MIL-PRF-19500/698
AMENDMENT 1
22 January 2002

PERFORMANCE SPECIFICATION

SEMICONDUCTOR DEVICE, FIELD EFFECT RADIATION HARDENED (TOTAL DOSE AND SINGLE EVENT EFFECTS) TRANSISTOR, N-CHANNEL, SILICON TYPES 2N7470T1 AND 2N7471T1 JANTXVR, F, G AND H AND JANSR, F, G AND H

This amendment forms a part of MIL-PRF-19500/698, dated 16 August 2001 and is approved for use by all Departments and Agencies of the Department of Defense.

FIGURE 4. Safe operating area graph (2N7471T1)."

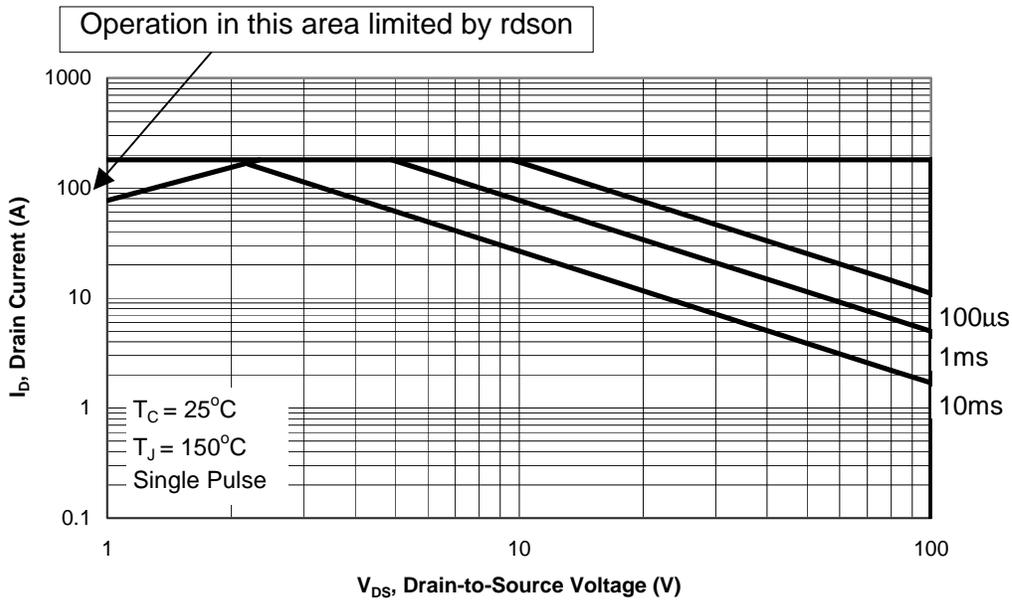
FIGURE 4, delete and substitute:

FIGURE 5. SEE safe operating area graph.”

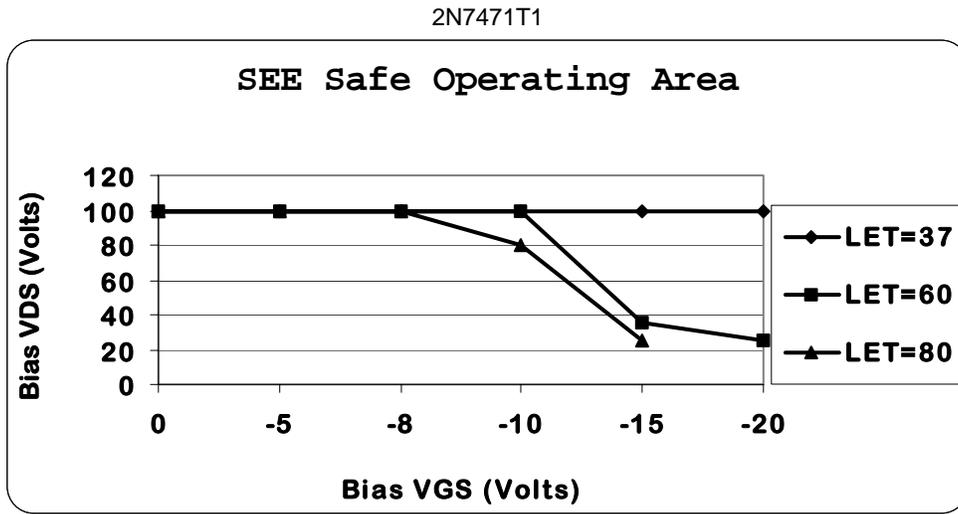
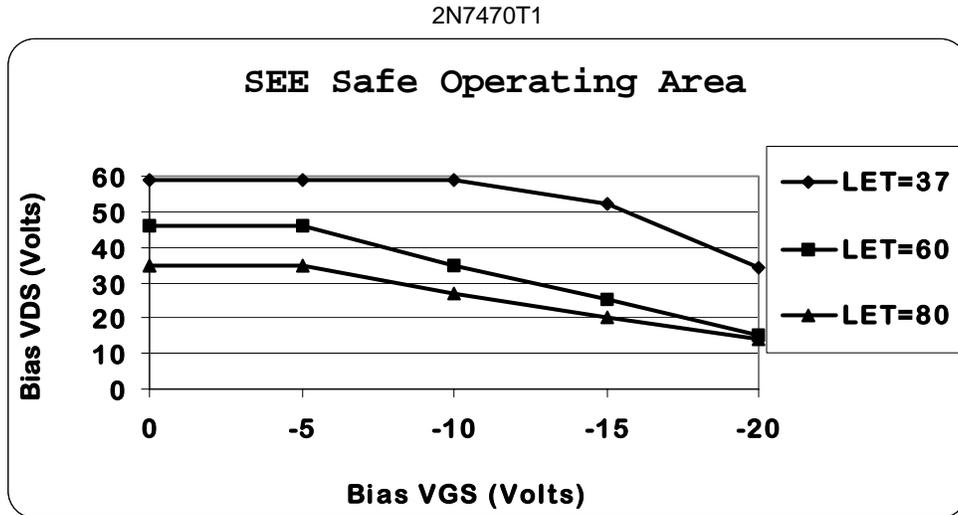
FIGURE 5, delete and substitute:
